Preliminary
Development Plan
PL2020-171
Lee's Summit, MO

Request to Modify Condition Number 3 of Ordinance No 7775

Current Elevations

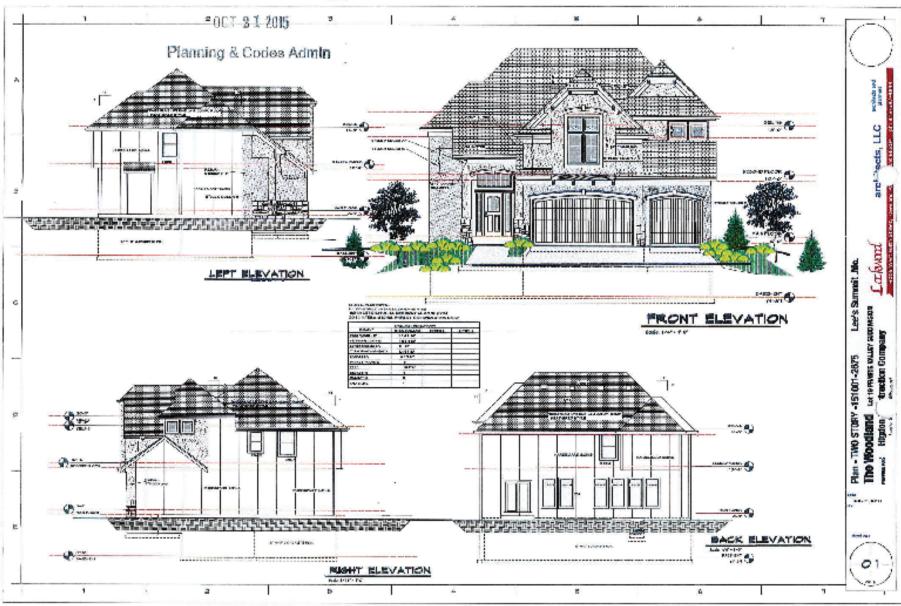
Front Mix of Stone and Stuco

Side Hardboard Siding

Roof Asphalt Shingle

Rear Hardboard Siding

Current Elevations

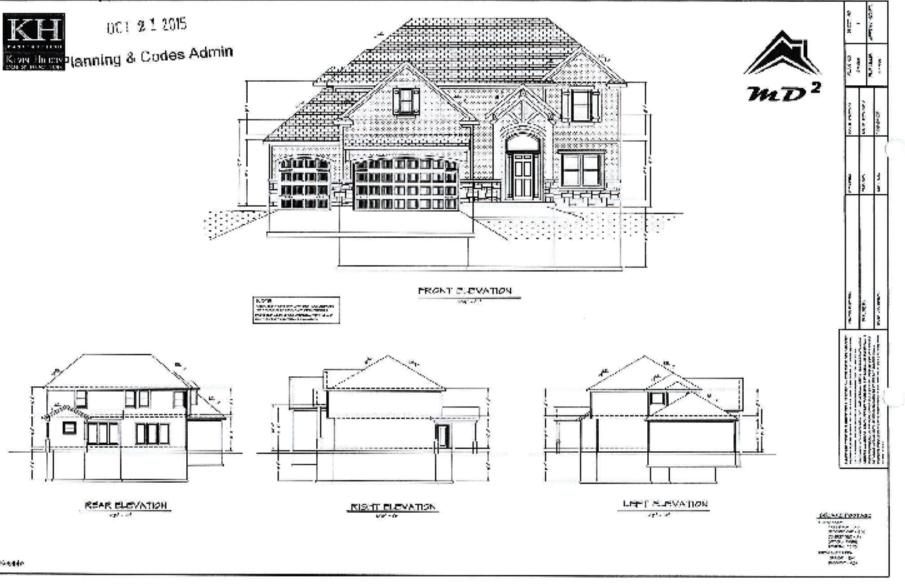
Front No Reference, Stuco?

Side No Reference

Roof No Reference, Asphalt Shingle?

Rear No Reference

The proposed modification will expand the approved materials and specifically exclude certain materials as stated below:

- -Wood Panel, Shingle
- -Stone or Brick Veneer
- -Real Brick or Stone
- -Fiber Cement Lap Siding, Panel or Shingle
- -LP Smart Lap Siding, Panel or Shingle
- -LP Smart Batten Board Siding
- -Natural Wood Accents, Walls or Beams

<u>Acceptable materials for roofing of homes</u> -Standing Seam Metal Accents

- -Asphalt Shingle

Side and Rear materials for exterior of homes -Any of the accepted materials for exterior siding

<u>Excluded materials for exterior siding of homes</u> -Horizontal or Vertical Vinyl Siding

- -Horizontal or Vertical Metal Siding
